NO.	REVISION	APPVD.	DATE
1	REVISIONS FOR ADDENDUM 1		1/2009
2	REVISIONS FOR ADDENDUM 2		6/2009

ROGER ROAD WRF TO INA ROAD WRF PLANT INTERCONNECT (SANTA CRUZ INTERCEPTOR – PHASE IV)

PLAN AND PROFILE
STA 209+00 TO 219+00

SHEET NO.: PP25A
OF

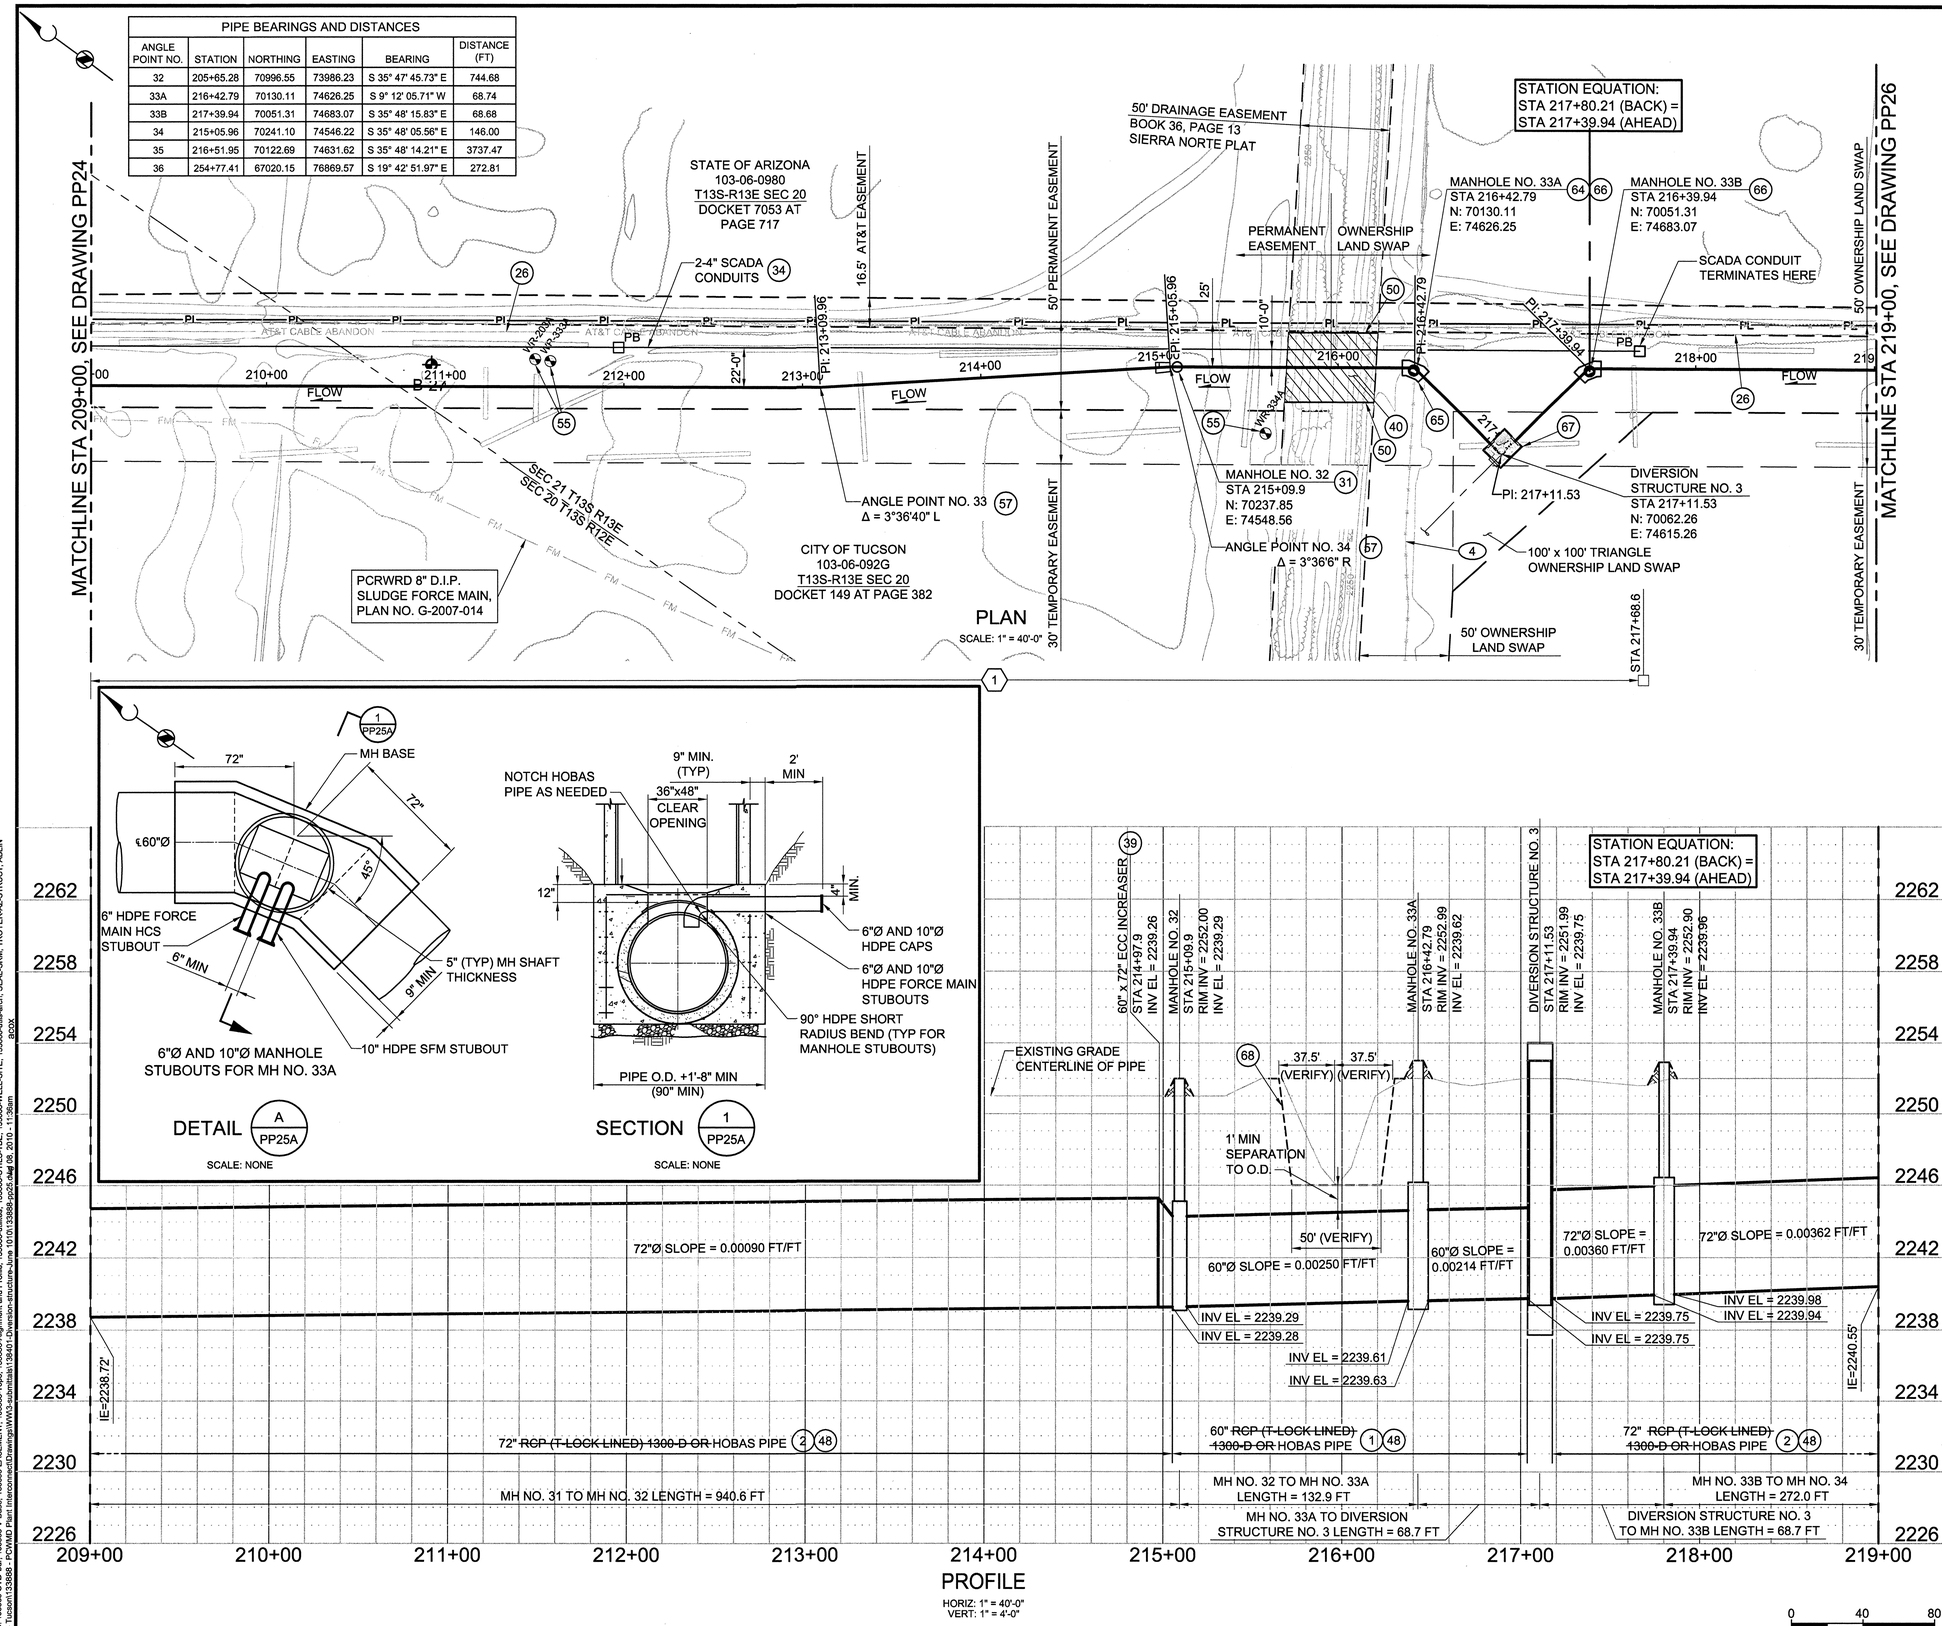
1. CONSTRUCT 60" ~~RCP~~ SEWER, SEE INSTALLATION DETAIL ON DRAWING C2; 196 LF
2. CONSTRUCT 72" ~~RCP~~ SEWER, SEE INSTALLATION DETAIL ON DRAWING C2; 826 LF

48. ~~HOBAS PIPE IS AN APPROVED ALTERNATIVE PIPE MATERIAL.~~ HOBAS PIPE, INC. SHALL DESIGN THE PIPE STIFFNESS PER THE DESIGN CRITERIA LISTED IN SPECIFICATION SECTION 15059 AND SUBMIT CALCULATIONS AS PART OF BID SUBMITTAL FOR REVIEW AND APPROVAL BY ENGINEER
